FORCE Outboards

service bulletin

No. 91-15

9.9 and 15 HP BIM Ignition System

Figure 1.

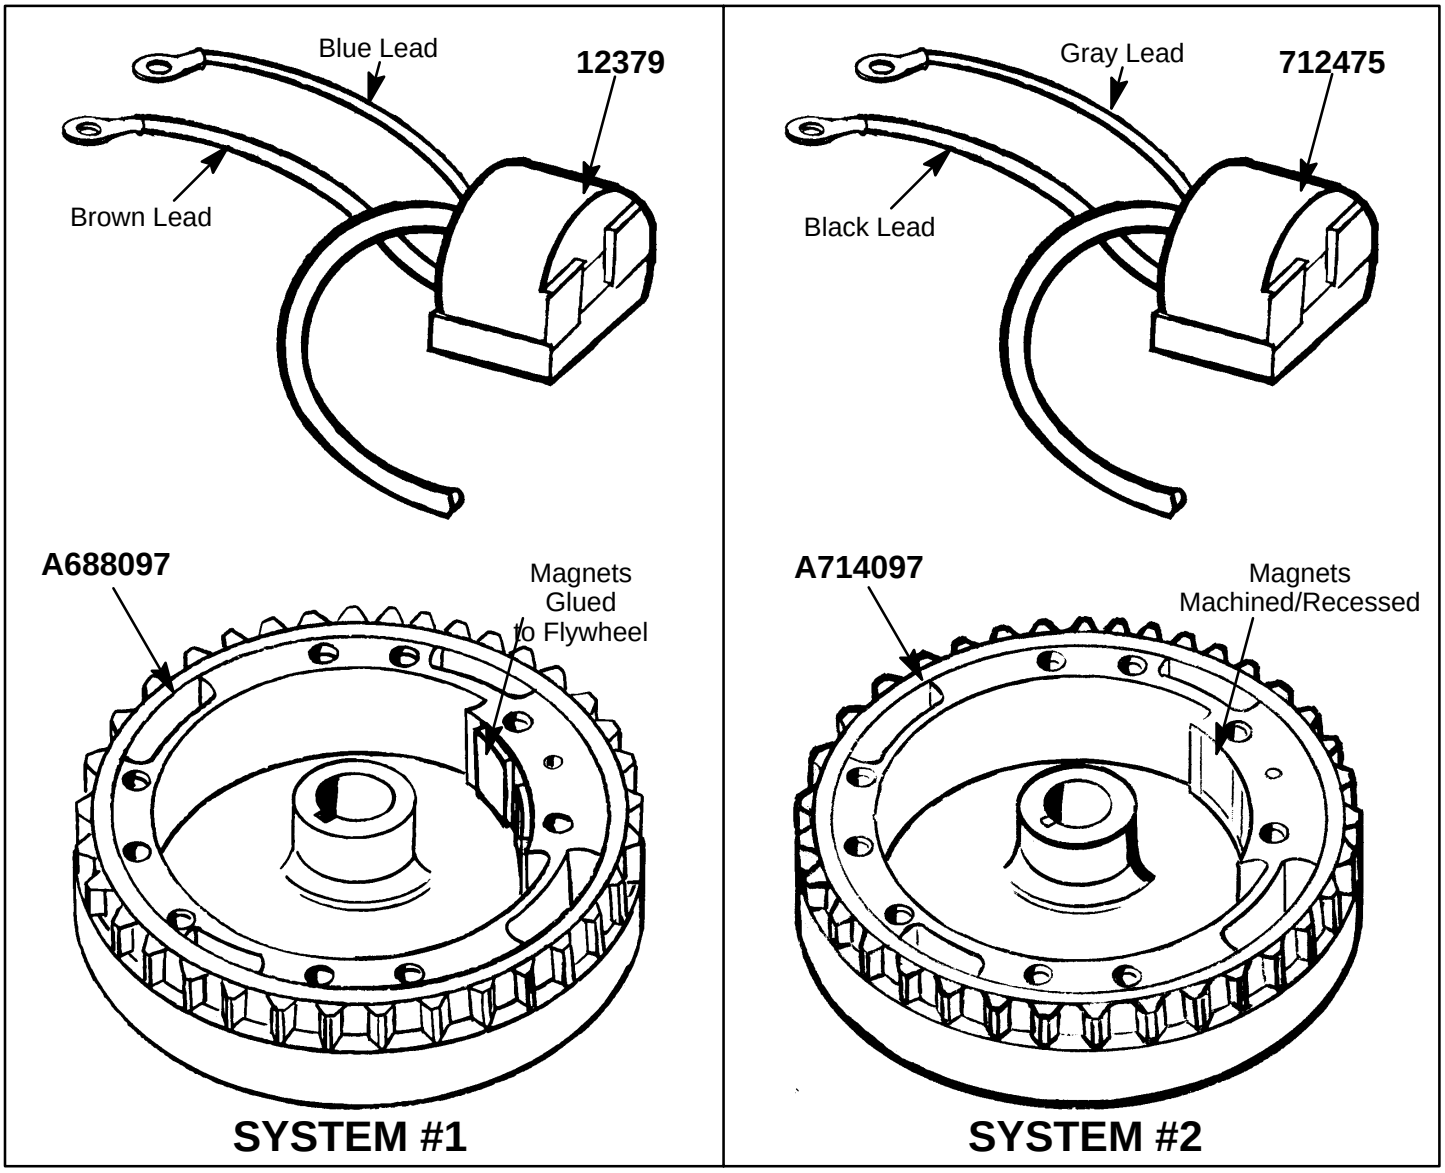
The 9.9 and 15 HP Force Engines for 1991 were built with two different BIM (Breakerless Ignition Module) Ignition Systems. The flywheel and coils differ and should NOT be intermixed. System #1 has a flywheel with the magnets glued on it and the coils have blue and brown primary lead wires. System #2 uses a flywheel with the magnets machined/recessed into the flywheel. The coils have gray and black primary leads. See Figure 1 for component identification and part numbers.

Intermixing components from one system to another will cause an erratic running condition.
